FREQUENTLY ASKED QUESTIONS

State/Federal Project No. CFHWY00604/0001659

AMATS: Spenard Road Rehabilitation
Minnesota Drive to Benson Boulevard Project

Typical Section

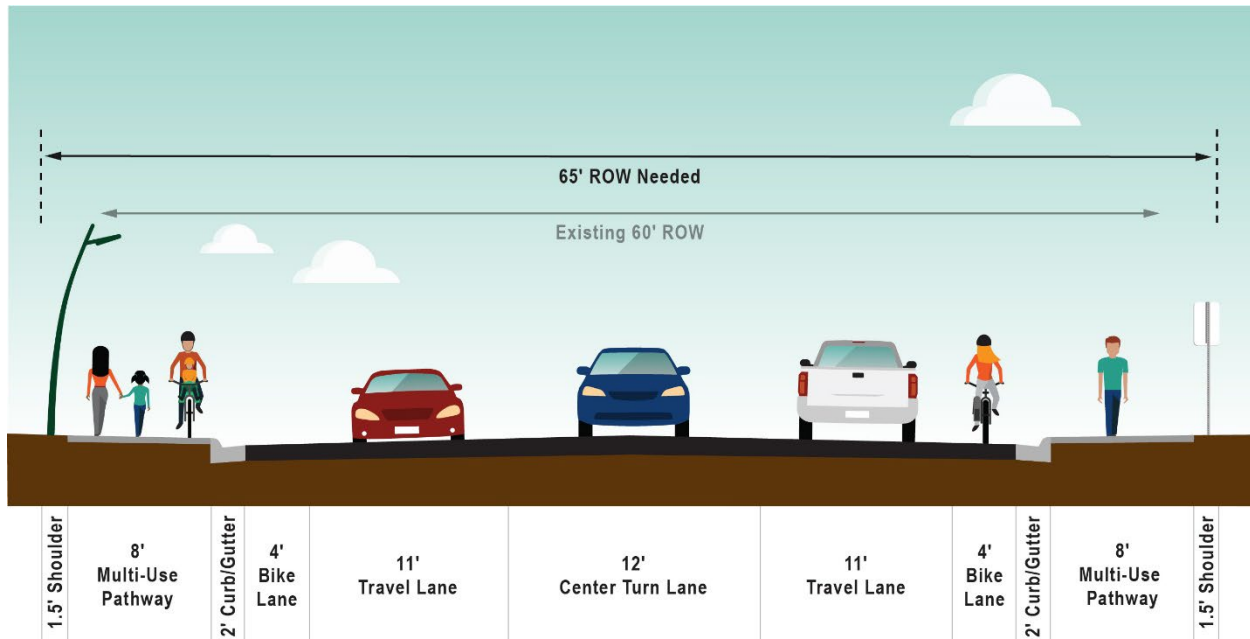
What will the road look like compared to the existing road?

How does a three-lane typical section handle traffic compared to a four-lane typical section?

Can the motorized travel lanes be narrowed to provide 6" more to the bike lanes?

Why does the typical section propose on-street bike lanes rather than integrating a bike lane on the sidewalk?

This section of Spenard Road is currently a 4-lane roadway with sidewalks on both sides. The proposed typical section (shown above) is a 3-lane roadway with on-street bike lanes and multi-use pathways on both sides.

Research indicates a three-lane roadway can handle similar traffic volumes to a four-lane roadway (up to 20,000 vehicles per day), with a comparable or even improved level of service. This was observed following the completion of the “road diet” reconstruction on Spenard Road from Benson Boulevard to Hillcrest Drive, and the project team expects a similar outcome following construction of this project. Current volumes on the corridor are approximately half of the upper limit for three lane facilities.

As a federally funded project, all ROW acquisitions must comply with the Uniform Relocation Assistance and Real Property Acquisition Act. Acquisitions for the travel lanes and the center turn lane are justified by the project's adopted design standards. The widths of the non-motorized facilities in the current typical section also meet those standards, widening them would exceed them.

The project's authority to acquire ROW is limited to what is necessary and should generally be supported by the project's adopted standards. In other words, the travel lane widths can be justified for acquisition, but a bike lane exceeding adopted design standards cannot. For this reason, the project team cannot reduce the width of other roadway elements and reallocate that space to widen the bike lanes.

- This project evaluated facilities for a wide range of cyclists, from those who may prefer a sidewalk or path to confident riders looking to quickly get across town alongside traffic.
- Bike lanes adjacent to the street can make cyclists more visible to drivers, reduce the potential for pedestrian conflicts, and allow for uninterrupted travel at higher speeds.
- The selected alternative provides both an 8-foot multi-use path and a 5.5-foot on-street bike lane. By having both facilities, cyclists can choose their preferred path based on their ability and other factors, such as road conditions.
